WESTWOOD PLAZA SUBDIVISION, RESUBDIVISION OF LOTS B AND E, BURTON ADDITION TO

APPLICATION NUMBER 12 DATE August 4, 2016
APPLICANT Westwood Plaza Subdivision, Resubdivision of Lots B and E, Burton Addition to
REQUEST Subdivision

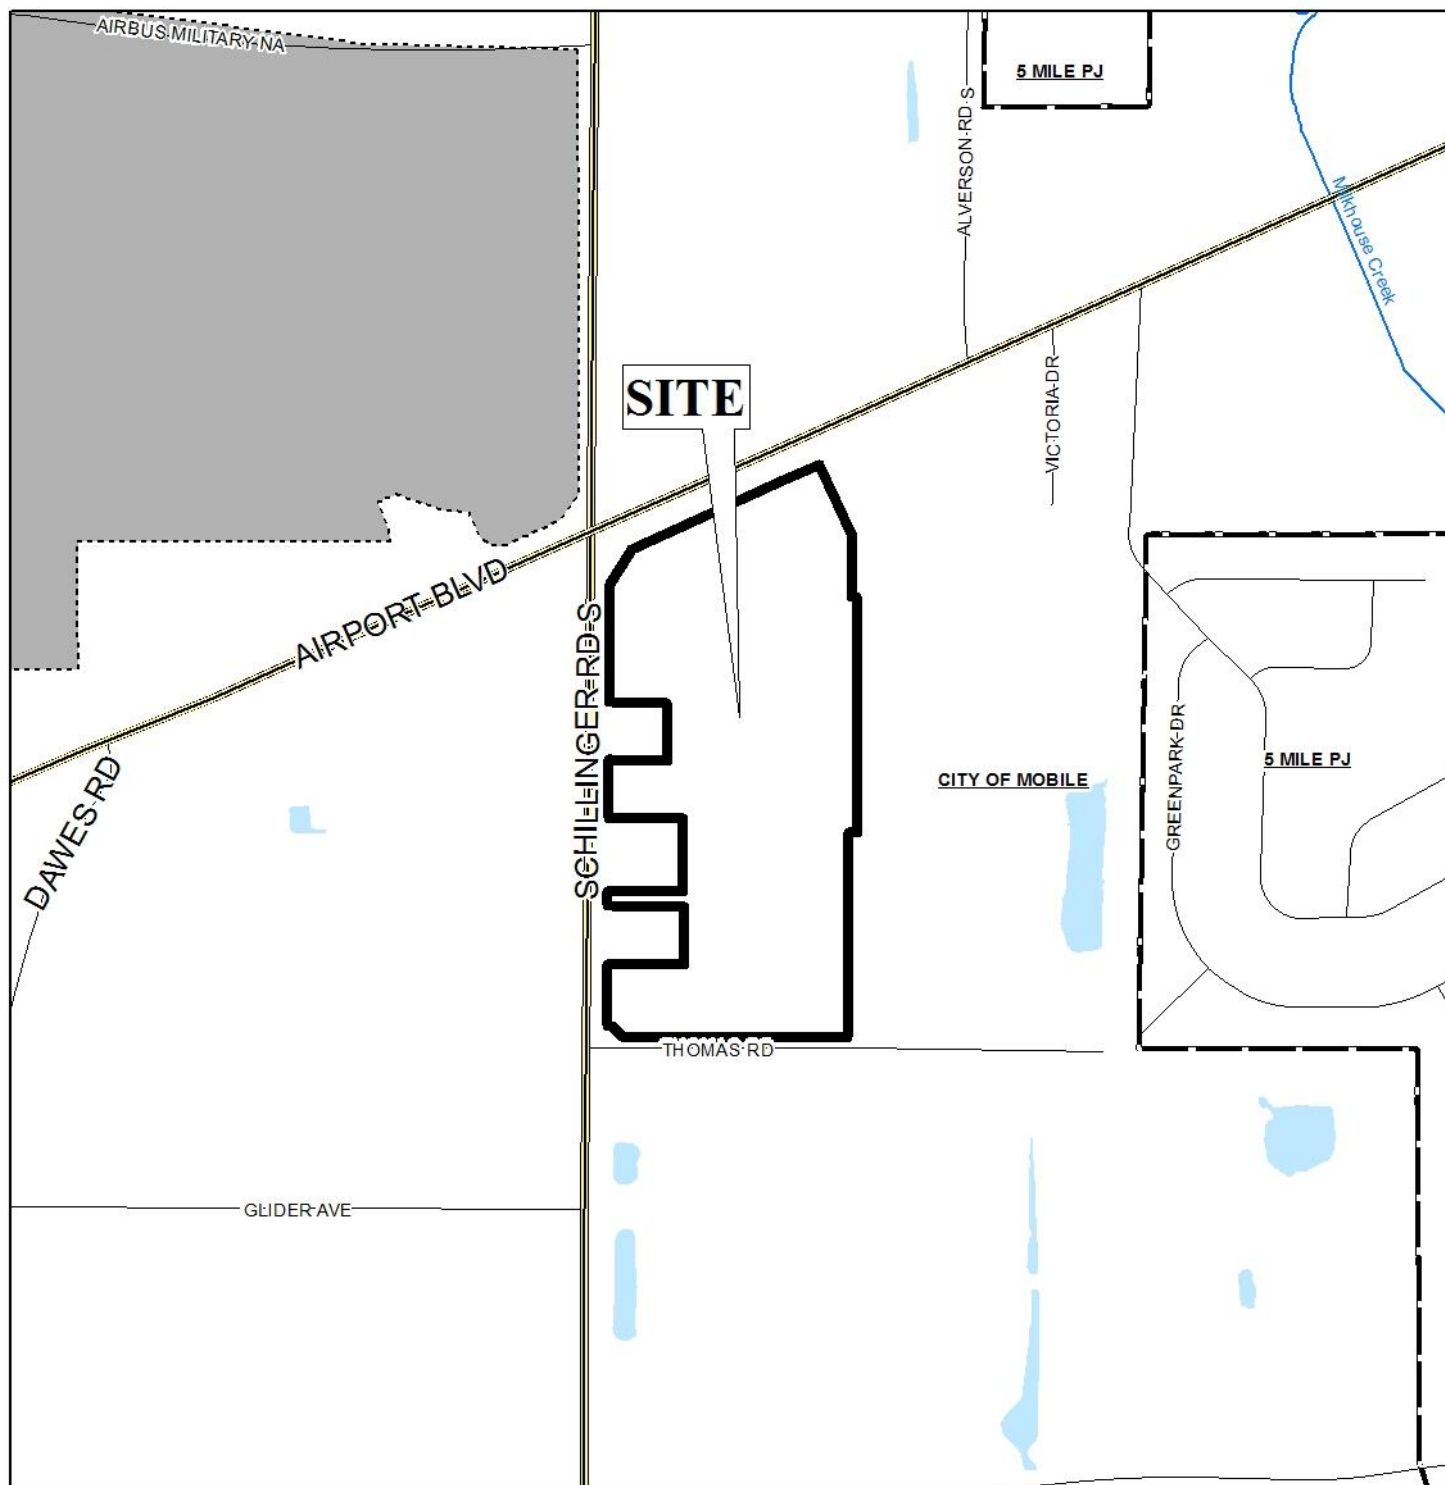
- B. Label the ROW dedication to the City of Mobile.
- C. Revise or clarify the POC labeled at the SE corner of Lot B-R.
- D. Provide the Field Date in Note #3.

The minimum building setback line, required in Section V.D.9., is depicted along all road frontages and should be retained on the Final Plat, if approved.

Various access, drainage, and utility easements are depicted on the preliminary plat and should be retained on the Final Plat, if approved.

- 5) Depiction of the minimum building setback line along all street frontages, as depicted on the preliminary plat;
- 6) Depiction of the access, utility, and drainage easements, as depicted on the preliminary plat; and,
